ADDENDUM NO. 3

February 25, 2022

DOUGLAS MACARTHUR ELEMENTARY SCHOOL ADDITIONS, RENOVATIONS, AND RELATED WORK

Crown Point, IN 46307

27. Sheet A-501

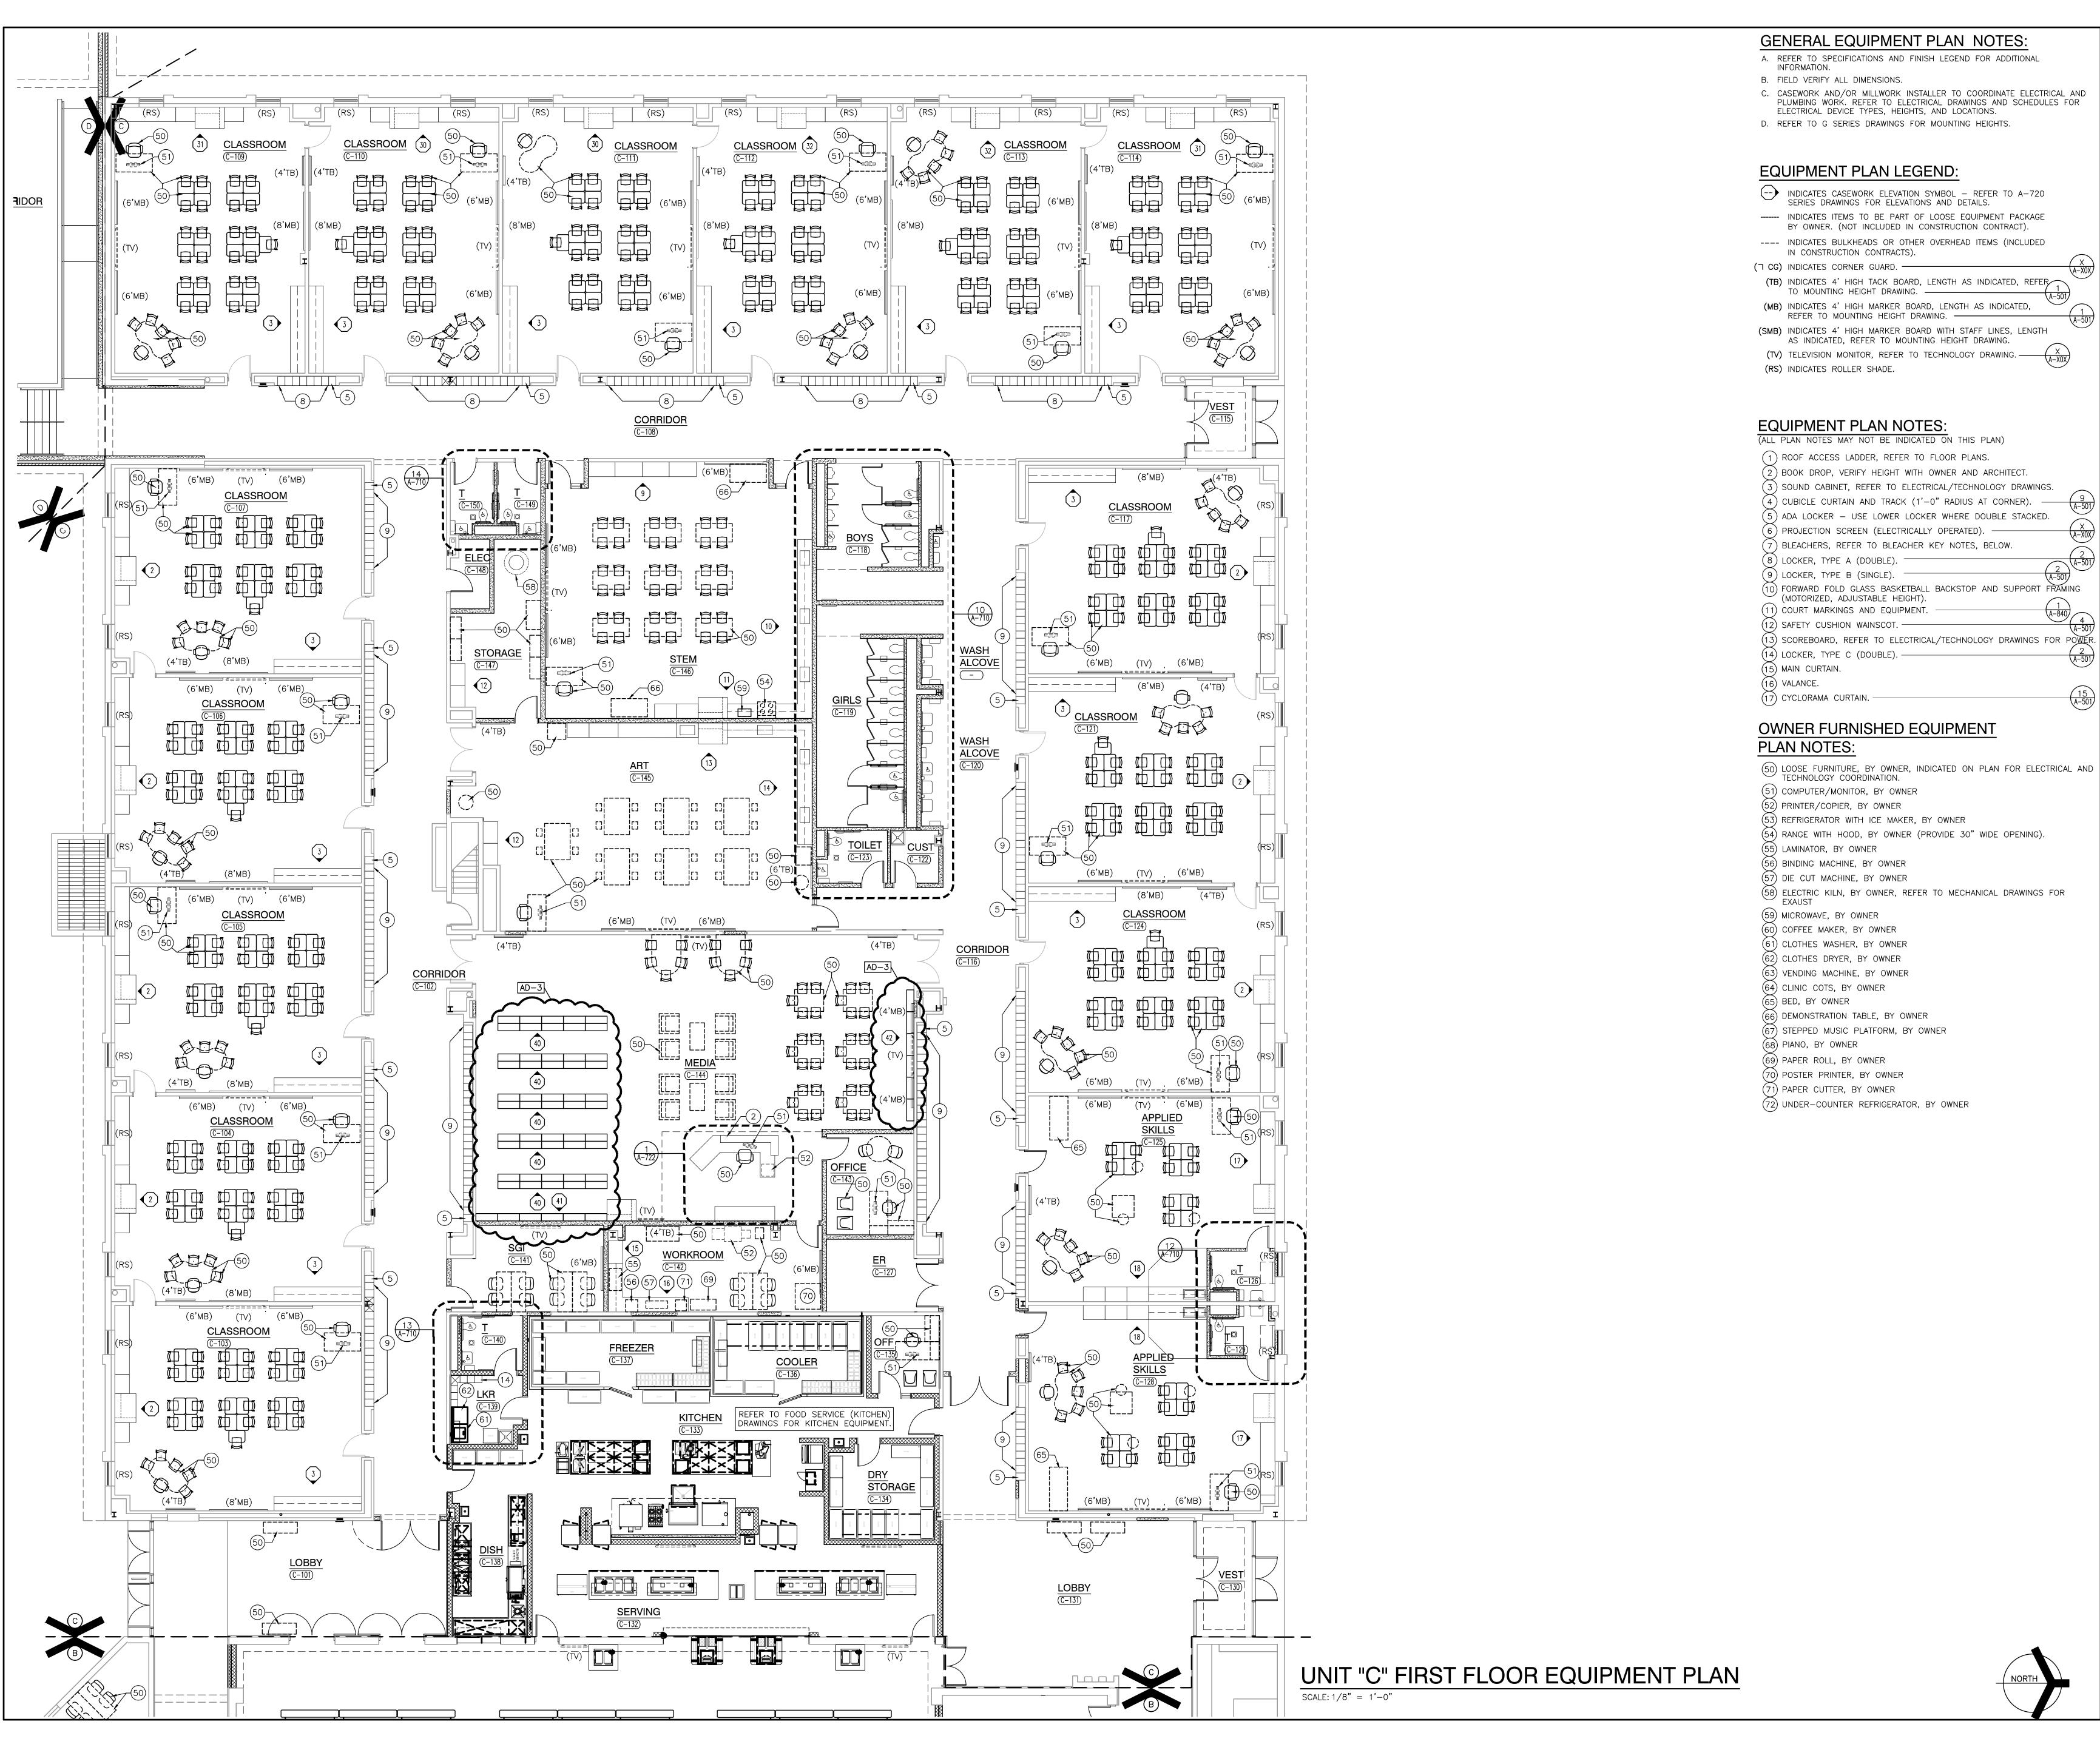
- A. Refer to revised, full size drawing, included in this Addendum, for the following revisions:
 - 1. Revise Detail 6/A-501 and 10/A-501.

PD103

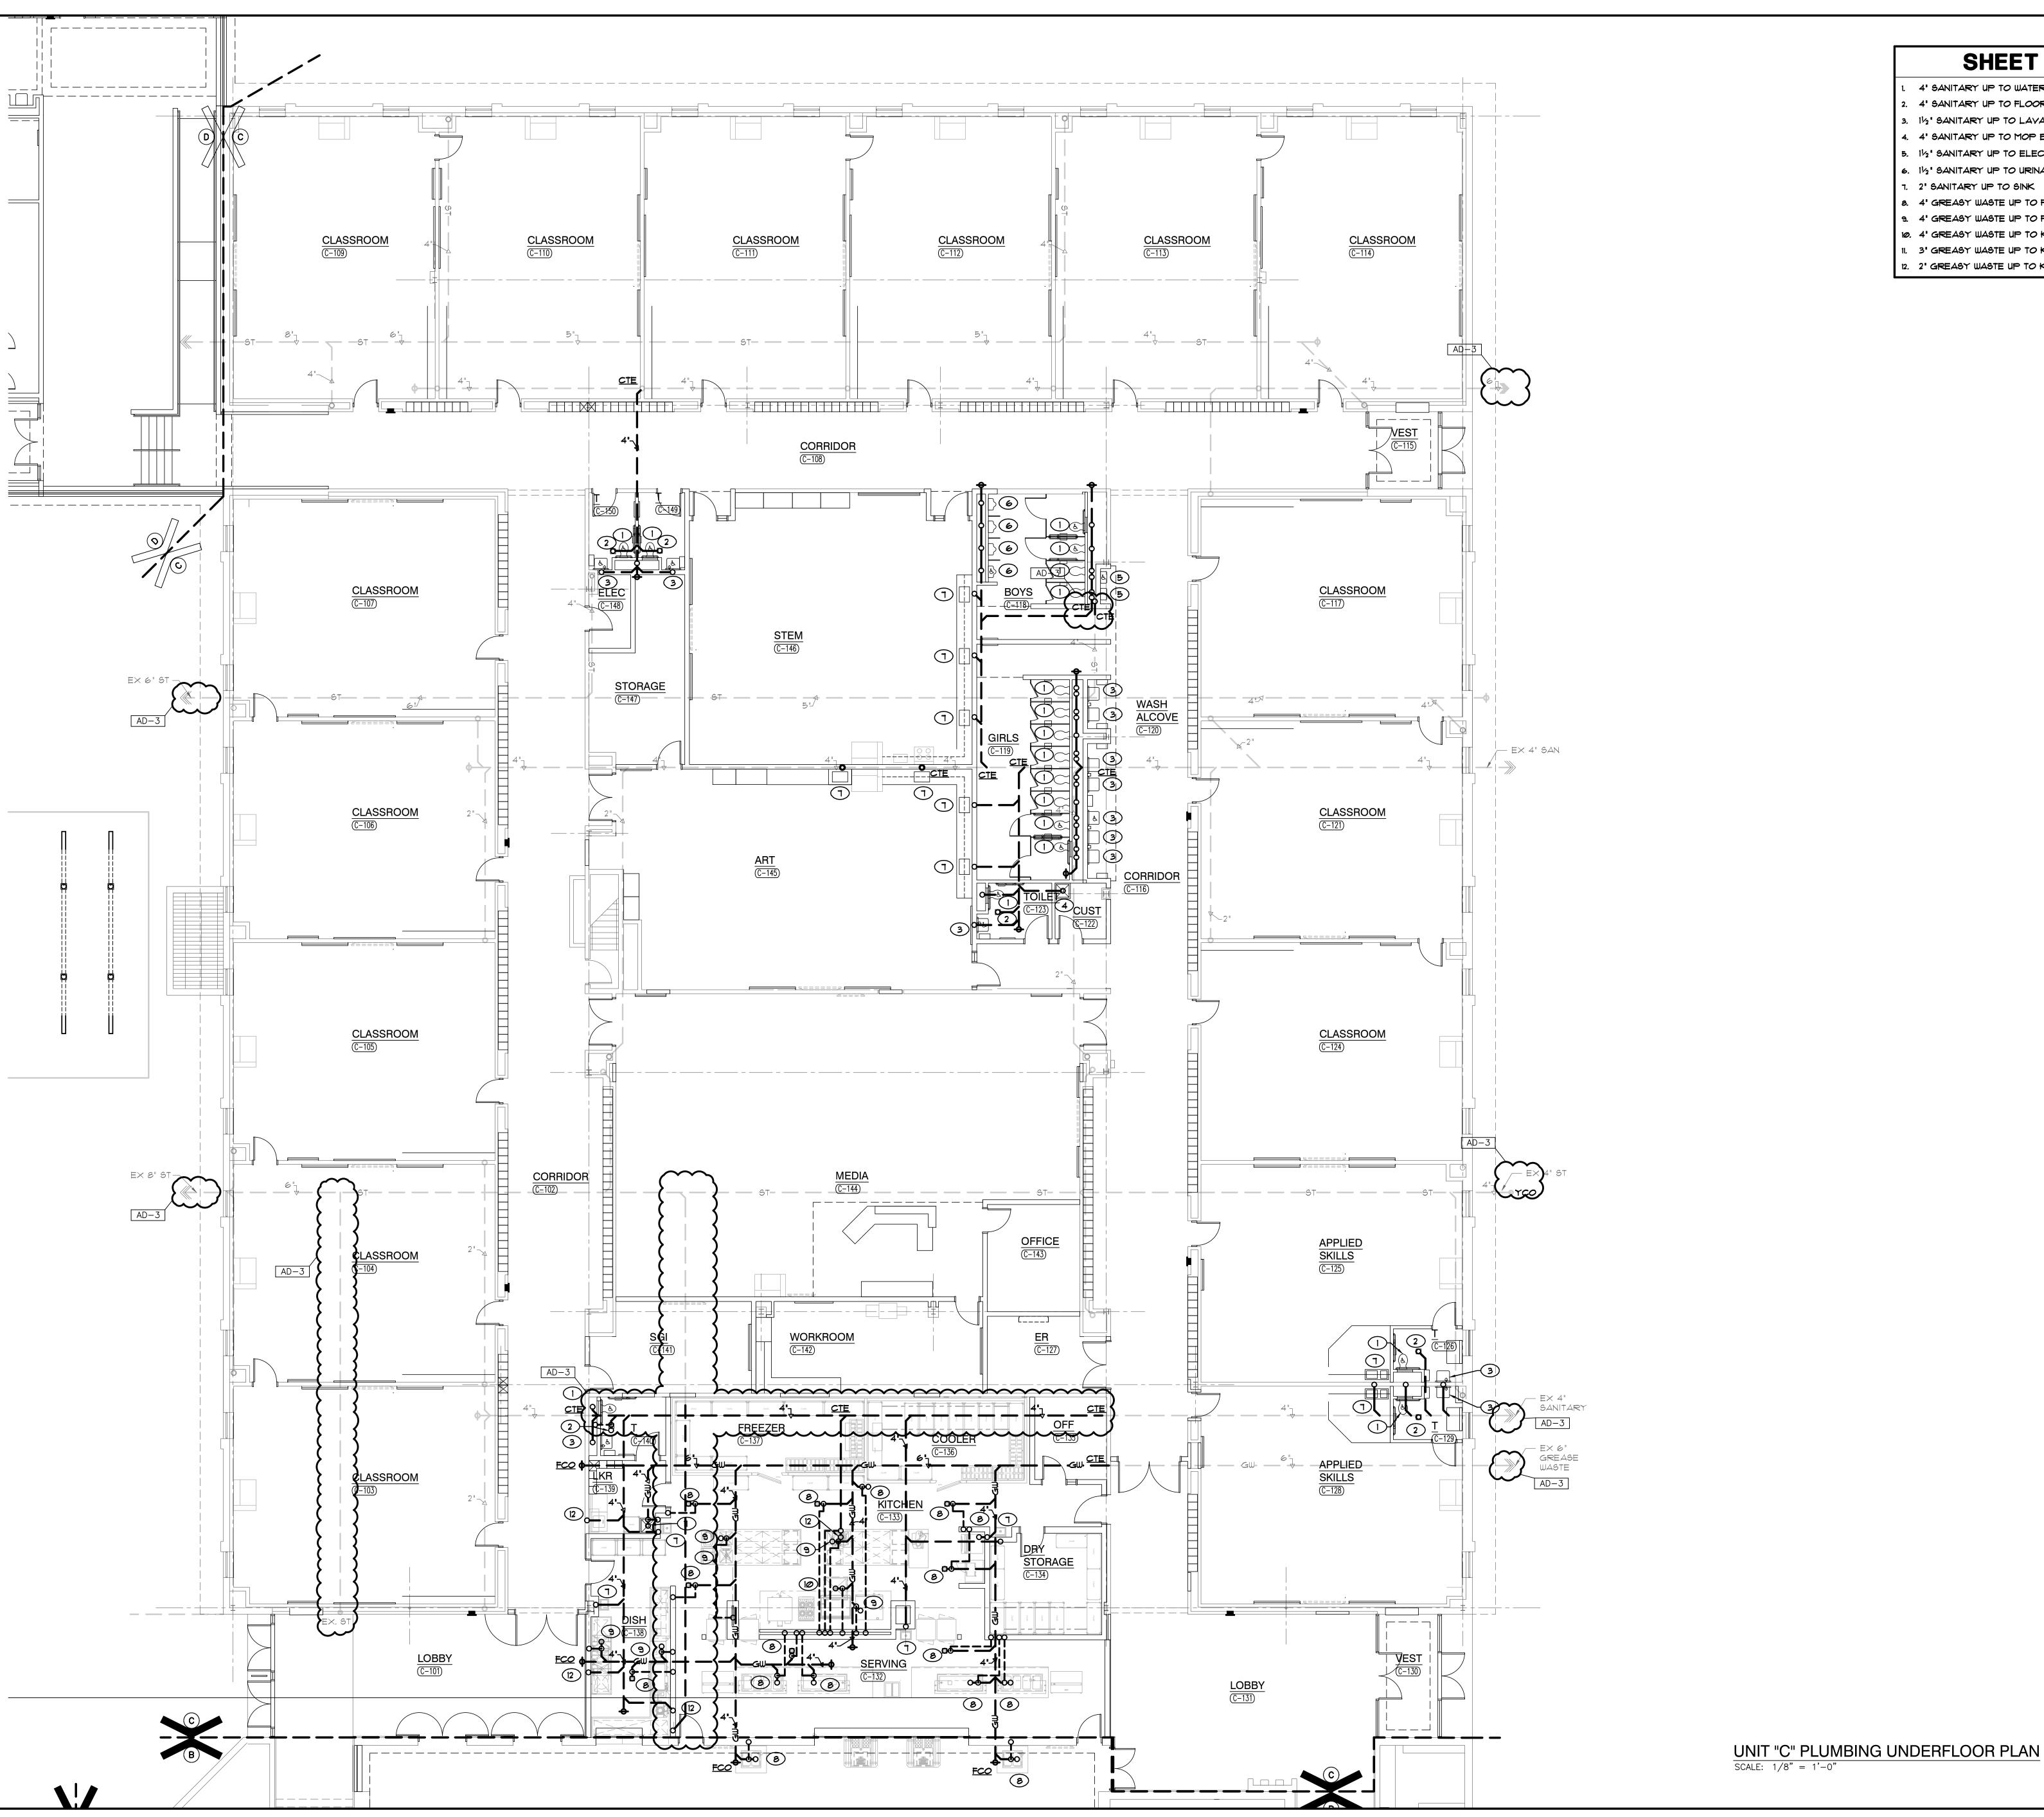
A. Refer to revised, full size drawing, included in this Addendum, for revised storm and sanitary piping.

GIBRALTAR DESIGN SHEET P-107

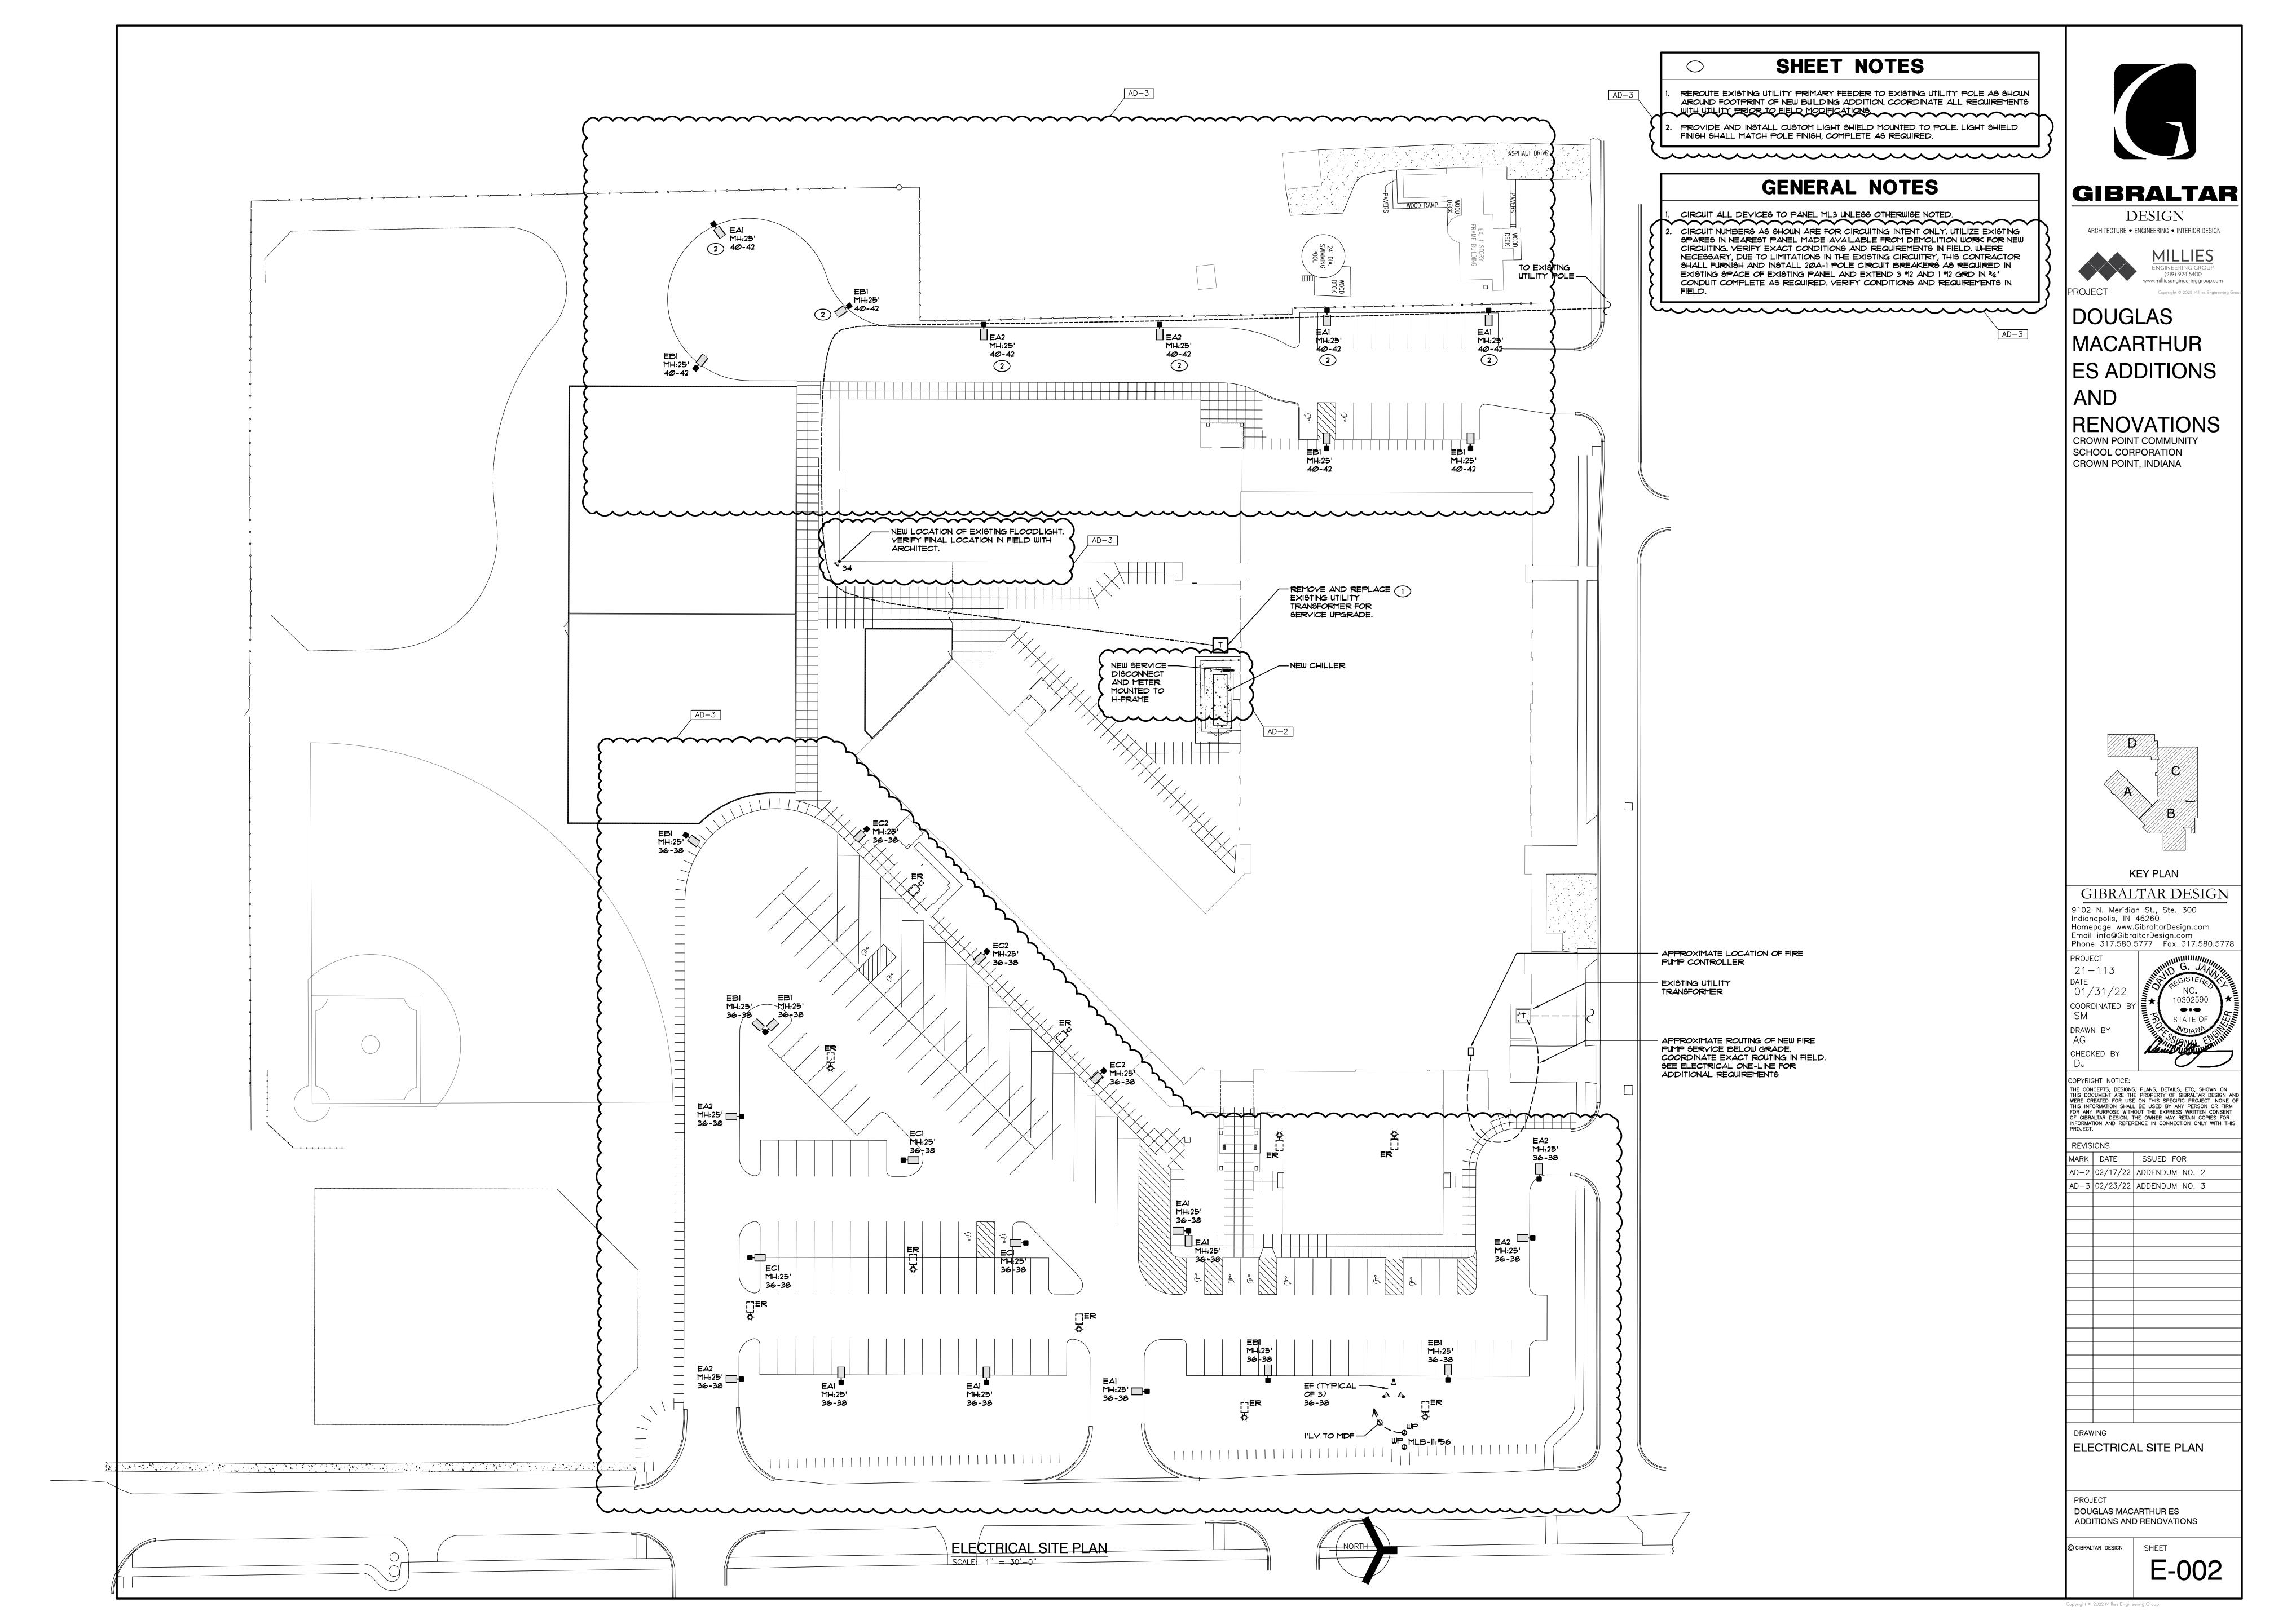
A. Refer to revised, full size drawing, included in this Addendum, for revised storm water piping.
